# Service Bulletin

Bulletin No.: 10-06-01-008I

Date: February, 2013

**Subject:** Engine Oil Consumption on Aluminum Block/Iron Block Engines with Active Fuel Management (AFM) (Install AFM Oil Deflector and Clean Carbon from Cylinder and/or Install Updated Valve Cover)

2740641

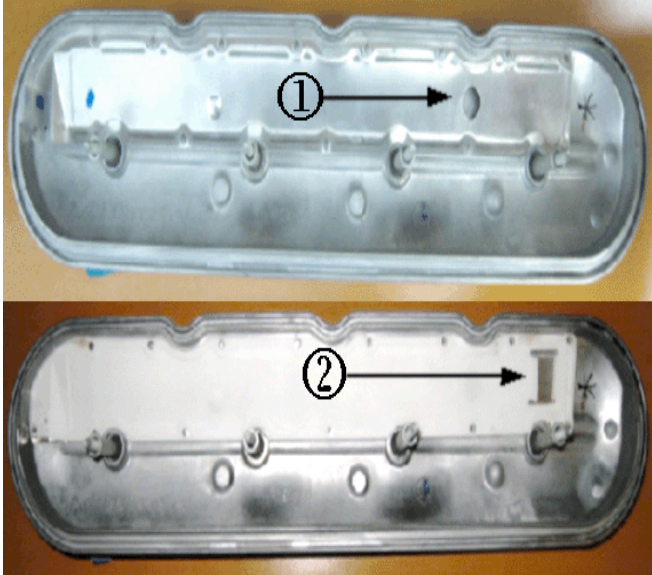
- 1) Old Design
- 2) New Design

PCV pullover or an overactive lifter can cause oil to be pulled through the PCV system even at low vehicle mileage. A correctly functioning PCV system will only leave a film of oil in the intake manifold. Inspect the intake manifold to see if there is any oil puddling in the bottom. If there is you will need to replace the left valve cover. Two new left rocker arm covers have been released for trucks and vans. Technicians should replace the left rocker arm cover with GM P/N 12570427 for 2007-2008 or GM P/N 12642655 for 2009-2011. Refer to the Parts Information below for the Camaro. This rocker arm cover has a relocated PCV drain hole that prevents oil from entering the intake manifold. Refer to Valve Rocker Arm Cover Replacement - Left Side in SI.

**Note:** These rocker covers are for specific years. The PCV orifice is different for each. The correct cover must be used or an SES light may set.

2474205

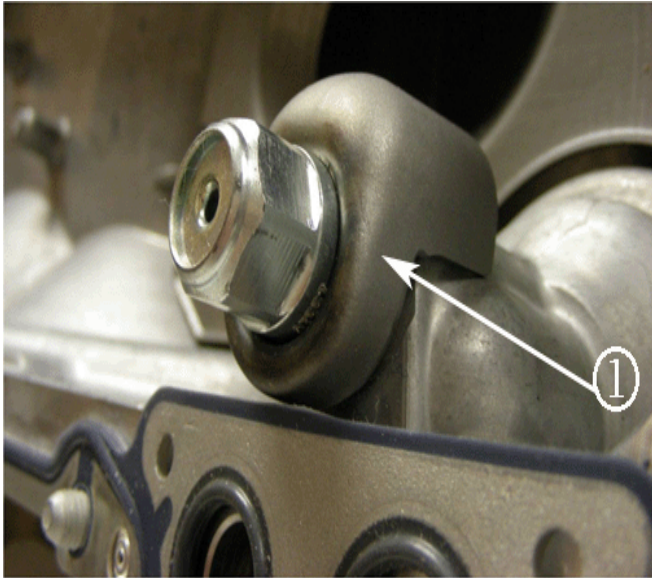
4. Remove the AFM valve (1).

2474207

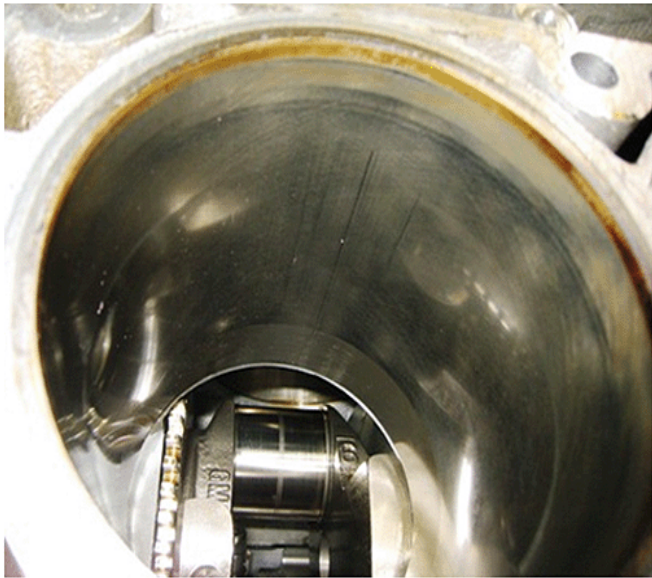
5. Install the new shield (1), GM P/N 12639759, and tighten the AFM valve to the oil pan to 28 N•m (20 lb ft).
